Interruption to playback (randomly skips tracks) of music from USB stick through KeylessGo Start.

Topic number	LI82.85-P-064064
Version	1
Design group	82.85 Navigation and Communication system (CNS, ICS, COMAND, FleetBoard)
Date	05-10-2016
Validity	Model series 217, 222 faulty playback of music track from USB
Reason for change	
Reason for block

Bild1 Mittelkonsole.jpg:

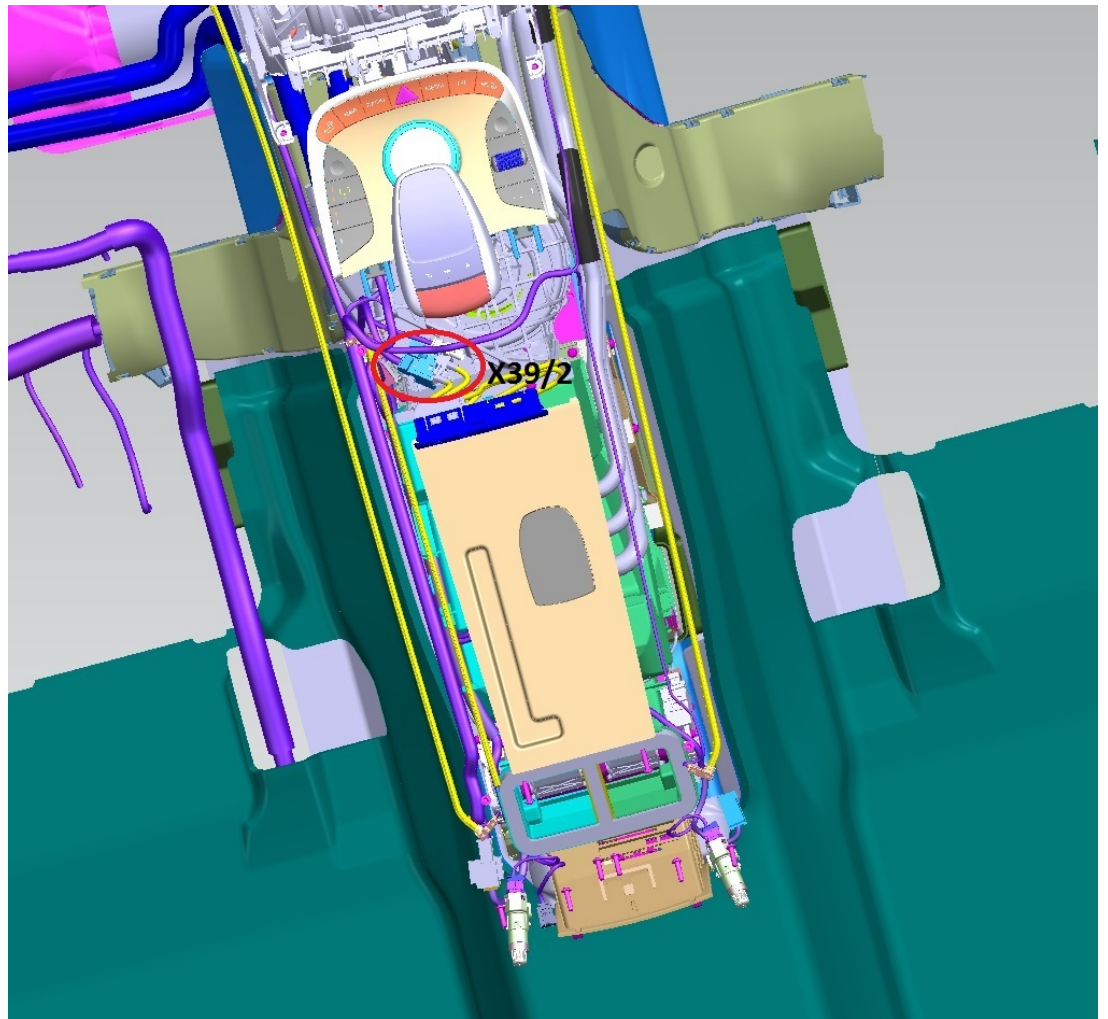
Shielding for USB line not connected to correct pin on head unit (HU).

The location of connector X39/72 is available in attachments 1 and 2.

New pinning on connector X39/72 (1.) and connector A and connector B on component A40/3 (2.).

Bild2 Stecker X39-72.jpg:

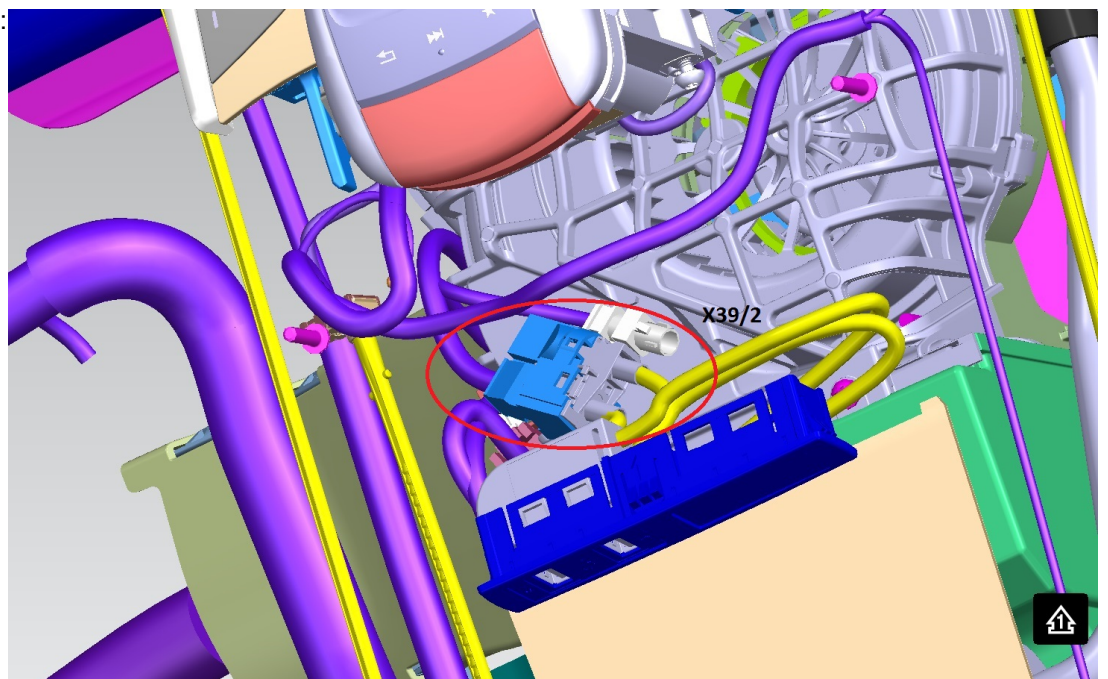
Remove following pin contacts from connector X39/72

0.5 YE (Pin 8)

0.5 BK (Pin 7)

0.5 TR (Pin 6)

Install pin contacts in new pinning location of connector X39/72 listed below

0.5 YE (Pin 7)

0.5 BK (Pin 6)

0.5 TR (Pin 8)
